CROSS Safety Report

Overestimation of lateral torsional buckling restraints

This month's report relates to a concern about the load capacity of a new temporary structure designed by another firm.

FIGURE 1: Plan view of temporary works structure

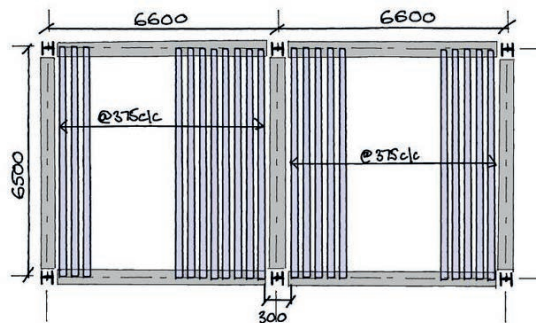
- 1) On plan, there were only two beams per bay, and they were both evenly and heavily loaded (**Figure 1**).
- 2) The lateral restraint points were not braced back to the support points (there was no diaphragm action).
- 3) The connections were not designed to be moment-resisting.
- 4) The load application was eccentric, introducing additional torsion, which had also not been considered (**Figure 2**).

The fundamental issue in the scenario described by the reporter is that just interconnecting the two beams does not constitute lateral restraint since there is nothing to prevent the two beams mutually moving sideways together.

To prevent such movement, you would typically need cross bracing in plan in the plane of the top flanges, or the beams supposed to be providing restraint would need to be connected back to something stiff.

FIGURE 2: Section view of secondary beam bolted to top flange of primary beam

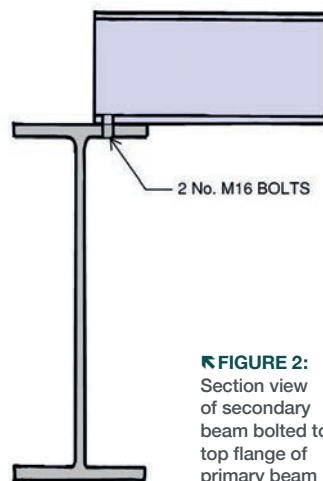
This concern was brought to the attention of the design engineer. After correspondence, it became clear that they had used an unbraced length of 375mm instead of 6600mm (larger by a factor of 18). They were relying on temporary beams bolted to the top flange for lateral top flange restraint (**Figures 2 and 3**). The reporter considers that the problem with this assumption was:
